Document Review Comment Sheet

PEB Ref. No : TB2-PEB-SDC-M1B-TVI-02734

DOCUMENT SUBMISSION STATUS:									
NOTE:									
	24 FEB.2014	FOR FINAL			S.W.E.	H.K.LEE	J.C.YOON	S.S.KIM	
	27 DEC.2013	BY OWNER COMMENT			S.W.E.	H.K.LEE	J.C.YOON	S.S.KIM	
	11 SEP.2013	BY OWNER COMMENT			S.W.E.	H.K.LEE	J.C.YOON	S.S.KIM	
	30 APR.2013	FOR PRELIMINARY			S.W.E.	H.K.LEE	J.C.YOON	S.S.KIM	
REV	DATE	DESCRIPTION				PREP	CHKD	APRD	APRD
OWNER		 VIETNAM OIL AND GAS GROUP (PVN)			OWNER'S CONSULTANT  FICHTNER			 PV POWER PCC	
EPC CONTRACTOR		 PETROMIETNAM CONSTRUCTION JOINT STOCK CORPORATION (PVC)			EPC CONTRACTOR'S CONSULTANT  WorleyParsons resources & technology WORLEYPARSONS				
POWER ISLAND PACKAGE SUPPLIER		 SOJITZ CORPORATION			DAELIM DAELIM INDUSTRIAL CO., LTD.				
PROJECT TITLE		THAI BINH2 THERMAL POWER PLANT 2 x 600MW

DRAWING TITLE		HP FEEDWATER HEATER #6 11LAD10AC006/21LAD10AC006 SKIRT & TUBESHEET ASSEMBLY							 SHEET 3/19
VENDOR NAME		FUNCTION		NAME		SIGN		DATE	
		DRWN		S.W.E.				24 FEB.2014	
		CHKD		H.K.LEE				24 FEB.2014	
		APPD		J.C.YOON				24 FEB.2014	
		APPD		S.S.KIM				24 FEB.2014

FIG. UG-118 FORM OF STAMPING

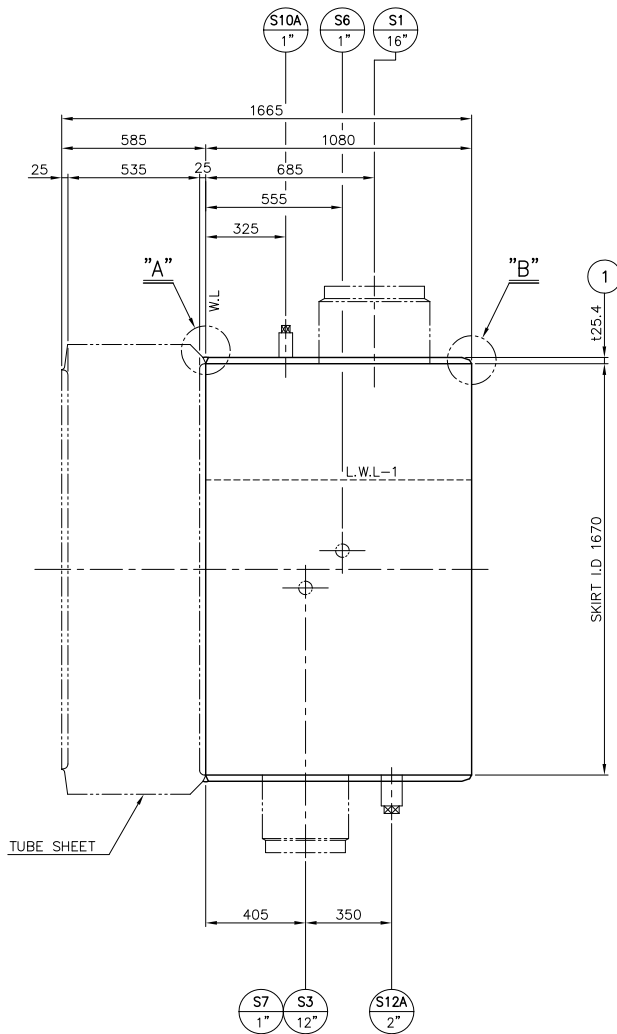
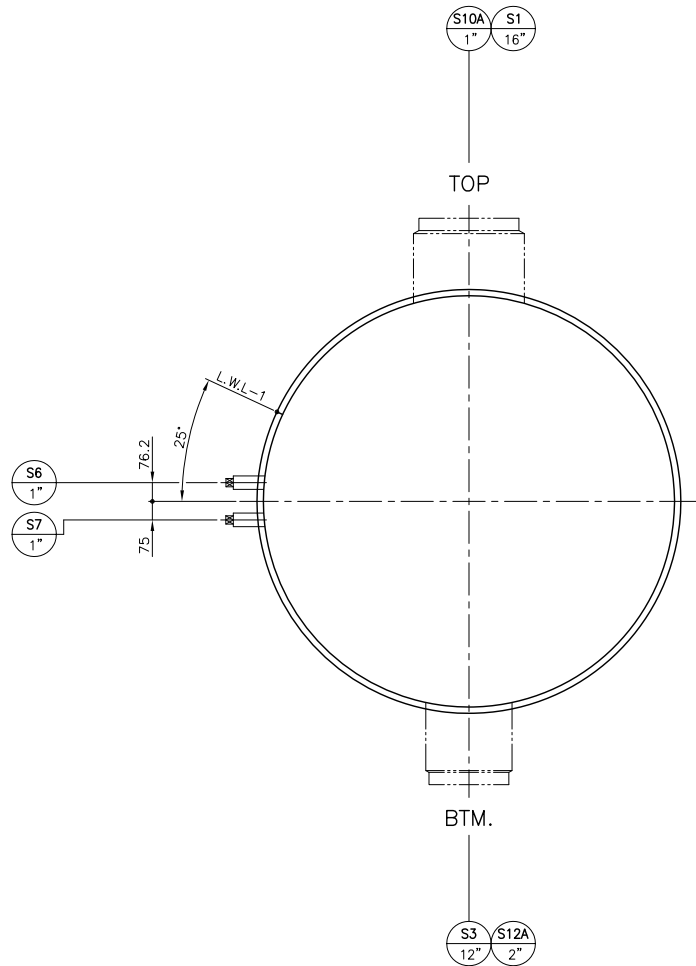
2	Please note that: Nameplates shall be in English with a minimum letter size of 6.4 mm.		ASME 'U'stamp project letter size was min 4mm.(UG-108). But we will used letter size 7mm.
